**Written comments with CAISO reply
Submitted after the
November 3 Stakeholder Meeting regarding the
2010 Local Capacity Requirement (LCR)
Criteria and Methodology and the
2010 LCR Manual**

**Comments of Southern California Edison Company on CAISO Draft 2010
Local Capacity Reliability Requirements Study Manual**

2010 LCR Study Criteria, Methodology and Assumptions

2010 Local Capacity Area Technical Study

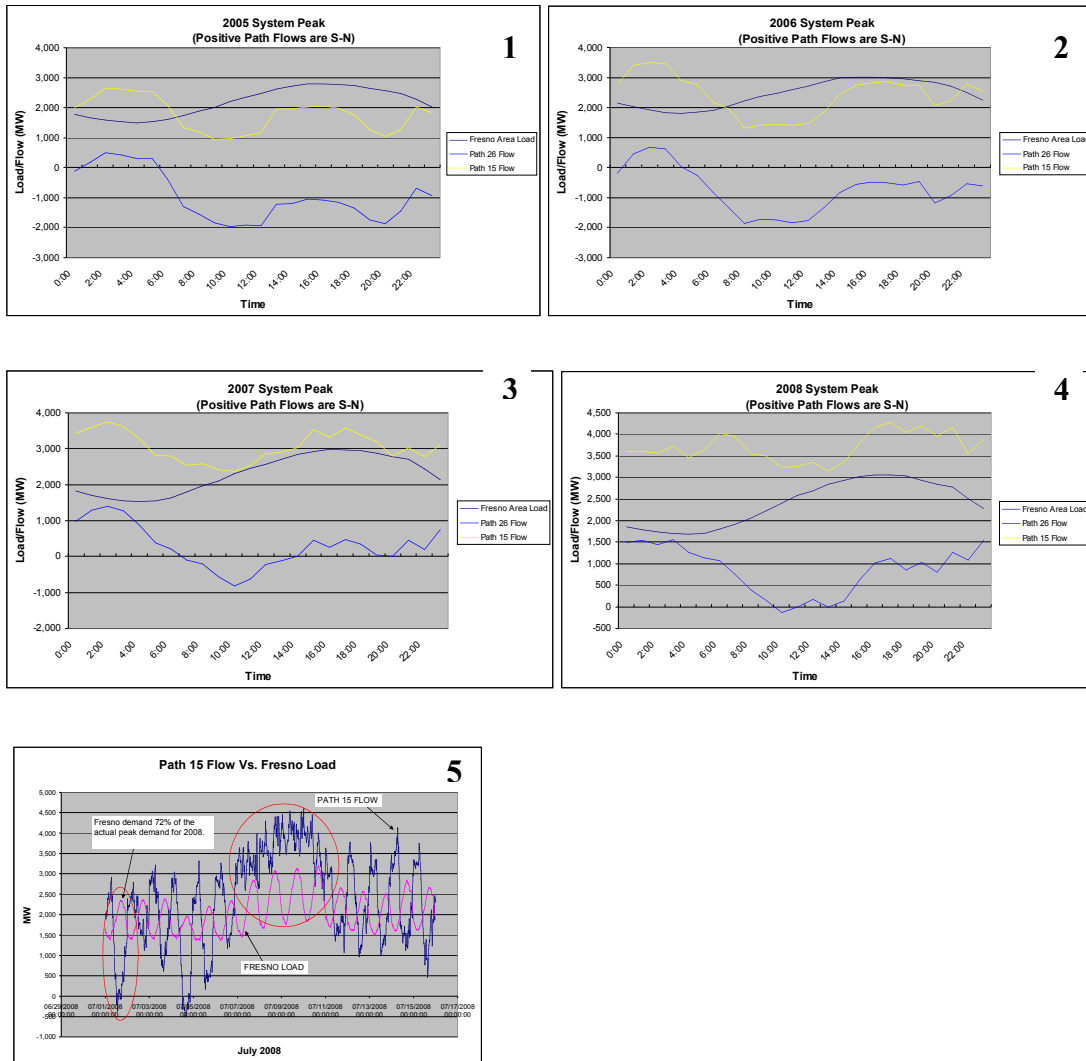
1. In the Draft Manual presented at the meeting, the CAISO has indicated that the Path 15 Flow will be kept constant at 1275 MW North to South (N-S) for the purpose of the 2010 Fresno Area LCR Studies. PG&E believes that this is a very unrealistic assumption to make and that it will unreasonably increase the LCR for the Fresno Area.

PG&E has analyzed Path 15 real-time data, which revealed that, for the past four years, the Path 15 flow has not been in the N-S direction during the Fresno area peak demand days. Typically, the Fresno area load peaks on the same days when the overall PG&E system peaks. Charts 1 – 4 below present the actual Fresno area load on the days the PG&E system peaked for the years 2005 to 2008. The charts show that on Fresno (and System) peak loading days, flows on Path 15 can be well over 2000 MW in the south to north direction (S-N). In addition, the charts indicate that

during these periods of high loading conditions, the N-S flow on Path 26 also decreases in relation to the Path 15 flow.

Additional data analysis indicates that N-S flow on Path 15 can occur during the summer time. However, this happens on non-peak days when the Fresno load demand is about 25% lower than the actual peak demand for that year. Chart 5 presents an example of the Fresno load demand and Path 15 flows for the month of July 2008. The chart shows a couple of days during this month when the Path 15 flow was in the N-S (~500 MW) direction but it also shows that the Path 15 flow will generally increase in the S-N direction as the Fresno area demand increases during the summer peak periods. PG&E would like to note that high N-S flow on Path 15 during summer peak periods, as proposed in the LCR Manual, is only possible when most of the generation south of the Fresno area is offline (on occasion this could include Diablo Canyon).

PG&E understands that the local capacity requirements study is inclined towards determining the local areas capacity needs under worst case scenarios. However, based on the real-time data, it is unrealistic to assume that the Path 15 flow will be 1275 MW in the N-S direction during Fresno area peak loading conditions. For the above reasons, PG&E recommends a range of -250 to 250 MW N-S flow on the Path 15 be acceptable for the purpose of the Fresno Area LCR studies. Assigning a range for the Path 15 will more accurately reflect the LCR needs of the local Fresno Area and it will also eliminate the need for adjusting the Path 15 flow after different steps in performing the local capacity technical study.

CAISO response: The CAISO coordinated the current Path 15 flow at Fresno Peak assumption with PG&E transmission planning before enforcement. The CAISO is willing to change this assumption if new evidence is made available to supersede the previous conclusion. First the data shown in here represents System Peak which may or may not coincide with the Fresno Peak. Please provide plots for all Fresno loads above 90% of the Fresno Peak vs. Path 15 flow for the last four years (not just the peak day and not compared to the system peak but rather Fresno peak load). Second the data submitted does not justify PG&E's proposed range of -250 to +250 MW N-S Path 15 flow but

rather a 4500 MW S-N flow. The Path 15 flow at the time of Fresno peak needs to be chosen in a manner that will allow the CAISO to manage Fresno constraints without market impact on Path 15. At this time the CAISO does not have enough new evidence to change the previously agreed upon assumption.
